# Design Review Board Agenda

**CITY OF MILL CREEK  
DESIGN REVIEW BOARD  
APPLICATION PL2016-0001**

**CITY OF MILL CREEK  
DESIGN REVIEW BOARD  
APPLICATION PL2016-0002**

**T.E.S.C., CLEARING & SWPP PLAN**  
 FOR  
**RAJ GILL 3 LOT SHORT PLAT**

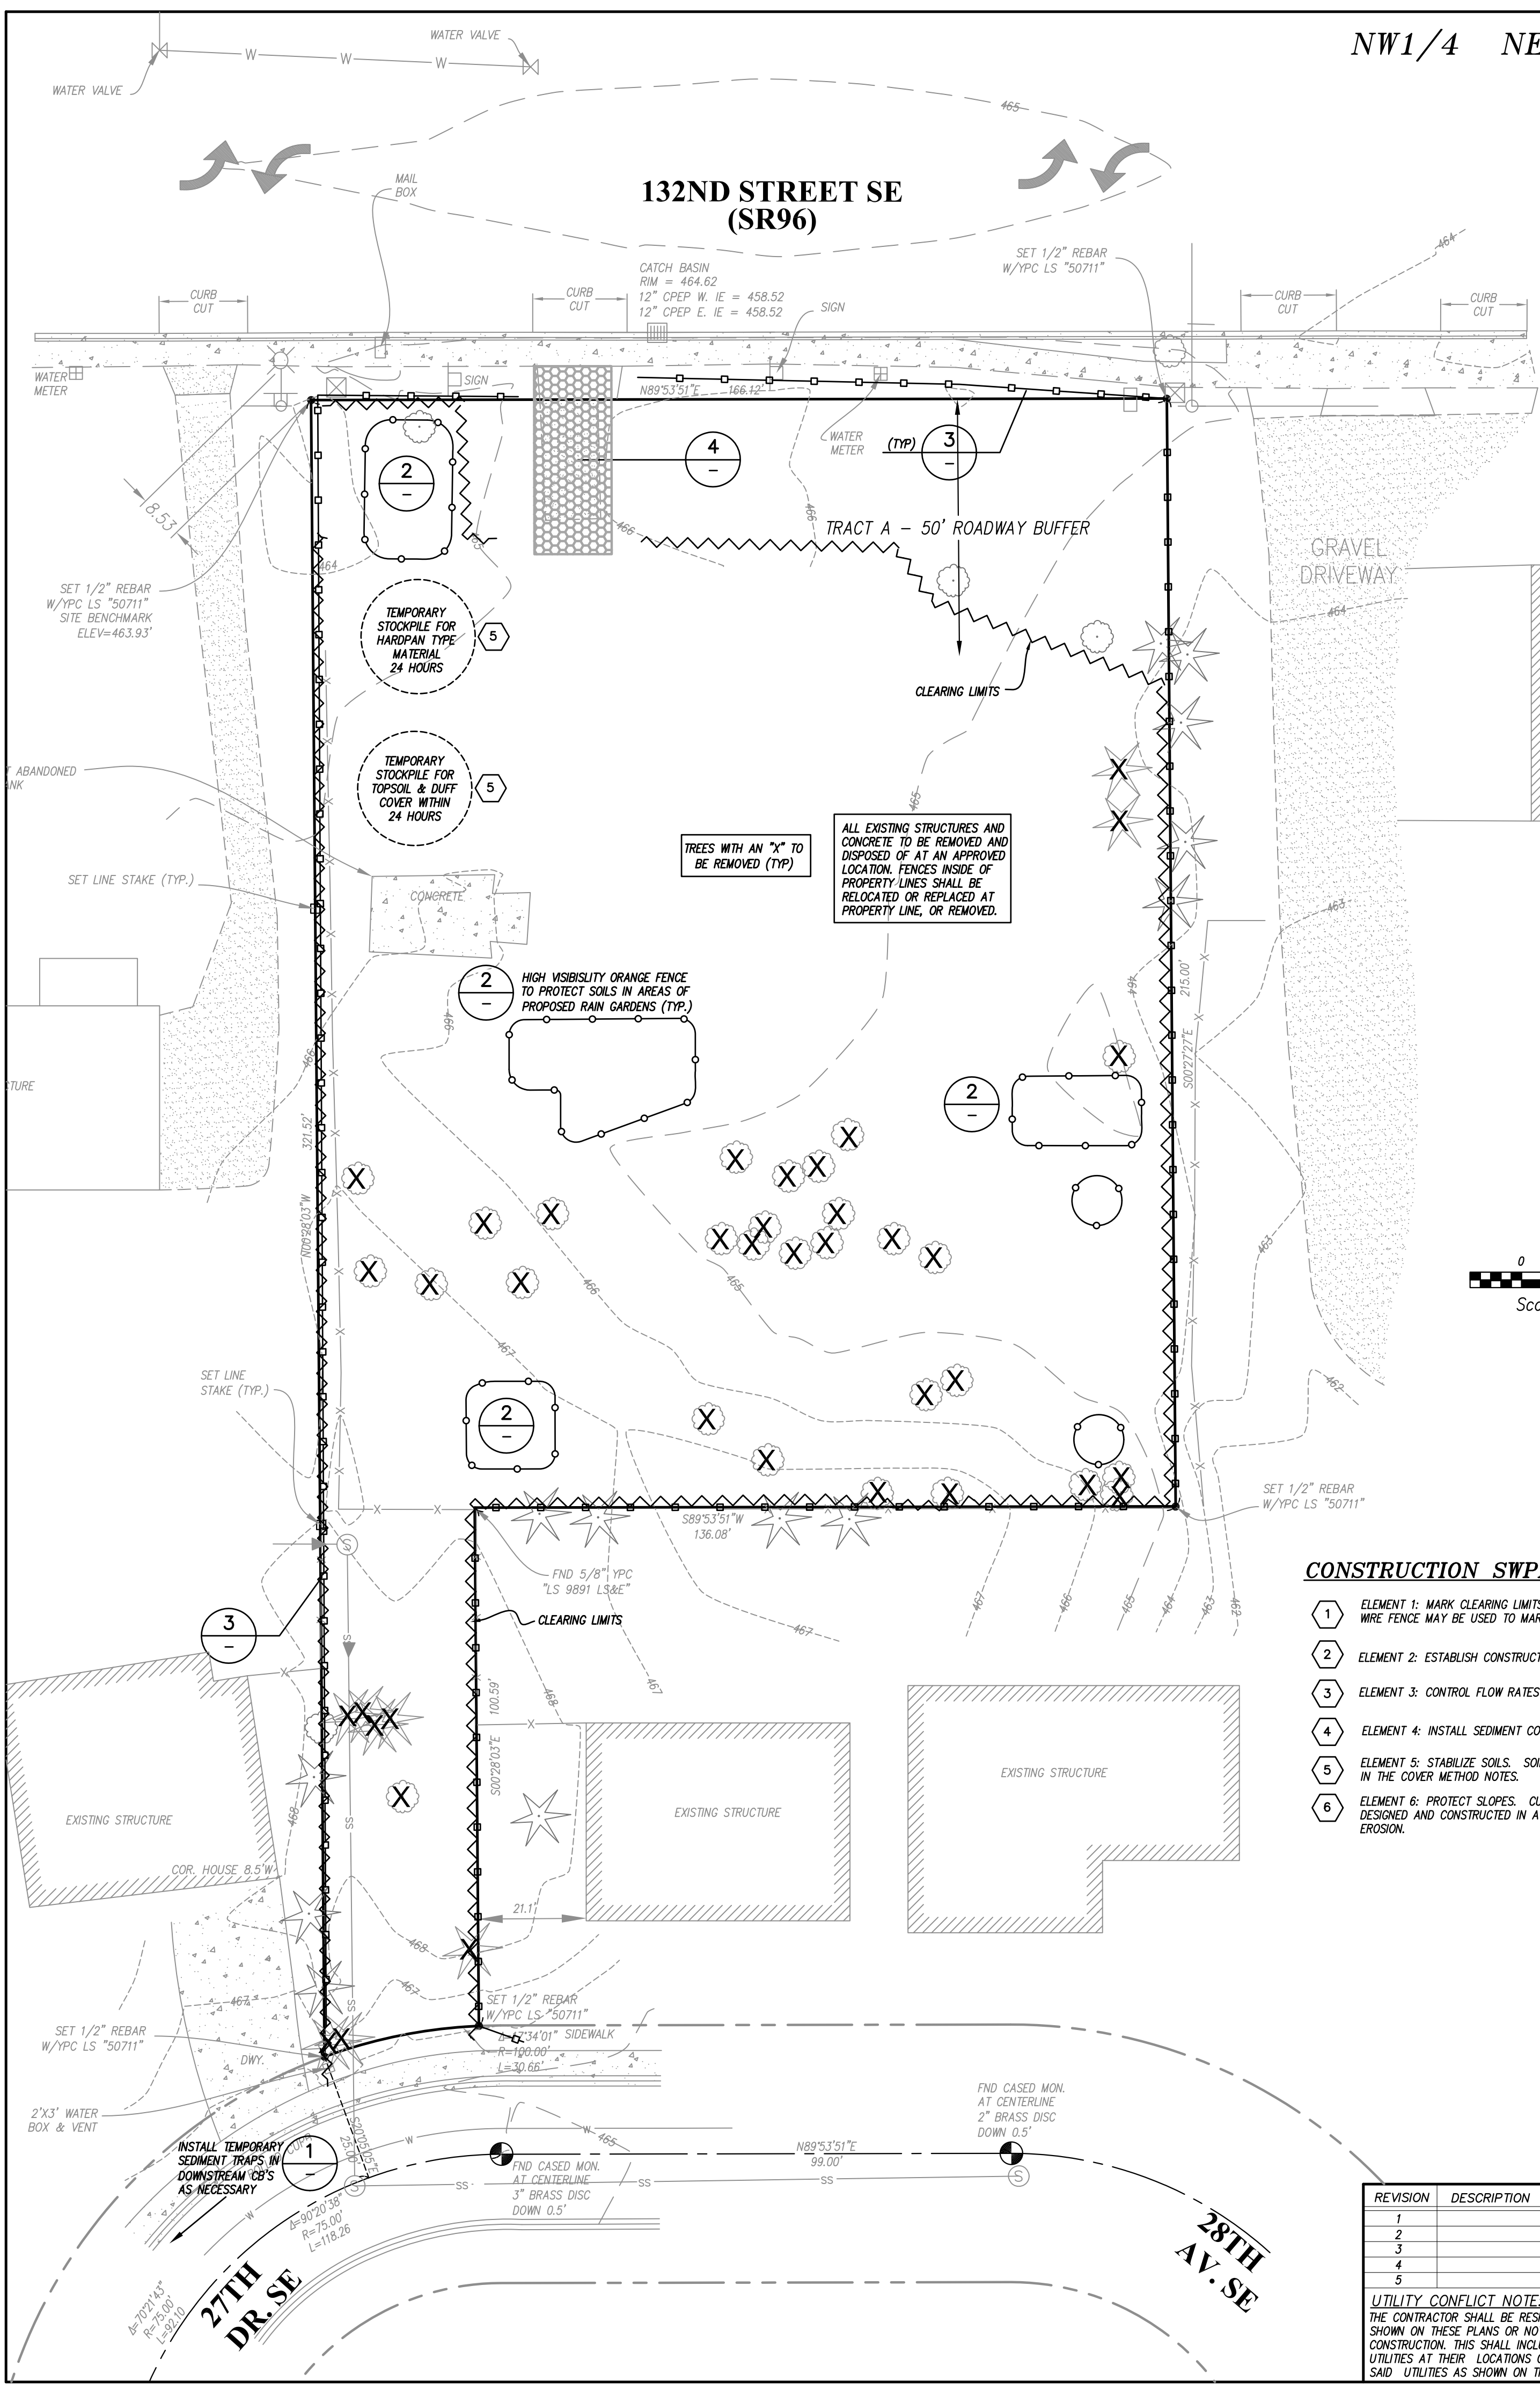
For the required 50-foot wide roadway buffer along 132<sup>nd</sup> Street SE, the existing trees will be preserved as indicated on *Sheet 2 of 3* and will be supplemented with trees and plantings as indicated on *Sheet L-1*.
